PERMIT

P 531057

ON-SITE SEWAGE DISPOSAL SYSTEM HOWARD COUNTY HEALTH DEPARTMENT BUREAU OF ENVIRONMENTAL HEALTH

ADDRESS: 3737 Sharp Rd PROPERTY OWNER: Katherine Carta

See Separate Sheet
for AS-Built

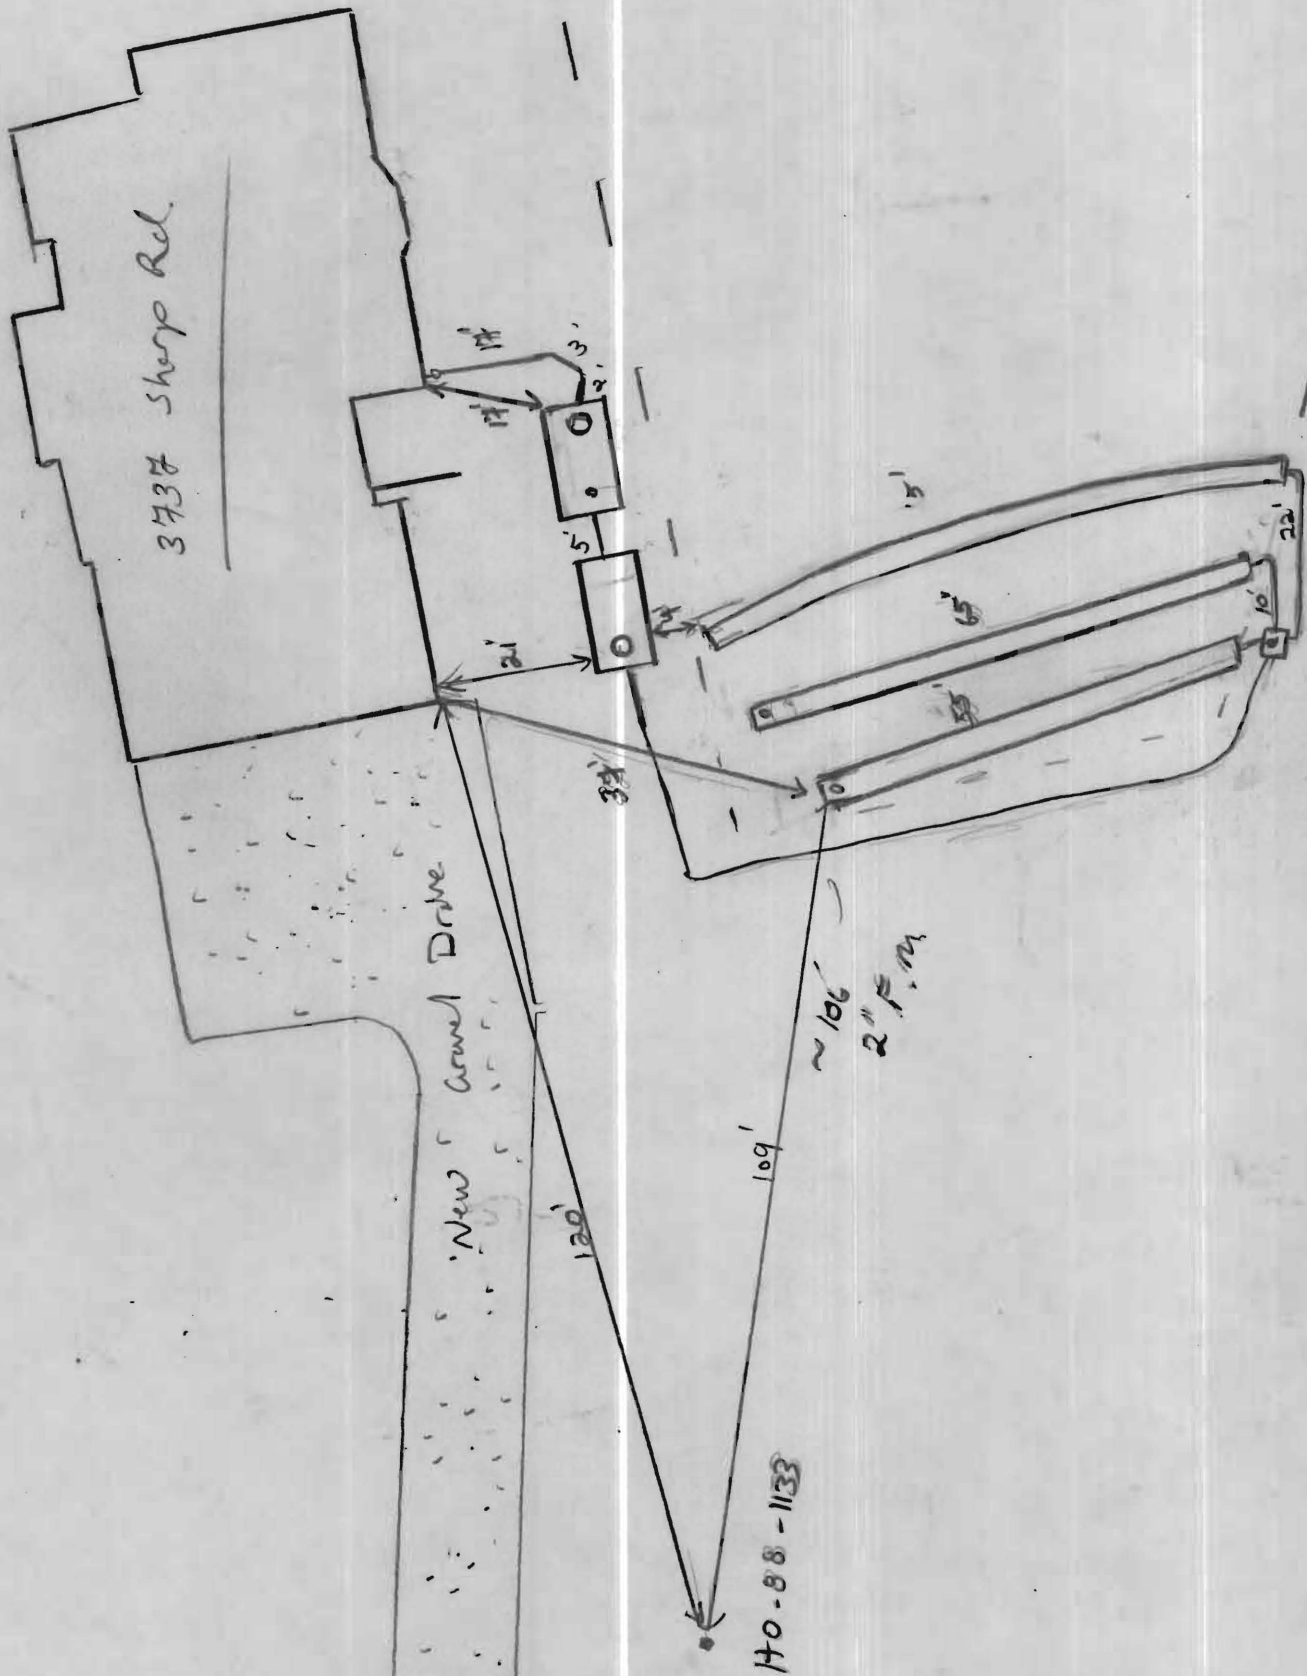
12/7/09 Pump and alarm working. Float
tree installed in tank. Electrical connections
on 4" x 4" outside of tank. Need to tie
together extra float wiring in tank. (RB)

6/25/09 Received call from contractor about questions on sys. design. Pulled the
only to realize that permit has not been paid for or received. Told contractor
to stop all work till further notice (KW) 6/26/09 Site visit made to
layout system. Talks were set. Told contractor that some rock
to be removed or tanks may need to be removed. Layout given.
Install 3 trenches. (55, 65, 75' long) to best contour. (KW)

7/1/09 F.M. ran to Dbox. Top most trench installed.

OK to continue. (KW) 7/2/09 Trenches complete. Contractor

used up some area for adjustment of contour. Explained to

homeowner about pump tank, alarm etc... Need p/A test

for final approval (KW) 11/30/09 P/A test failed. Told builder

need float tree and floats securely attached. All electrical connections

need to be mantled outside tank. Call to inspect and perform p/A
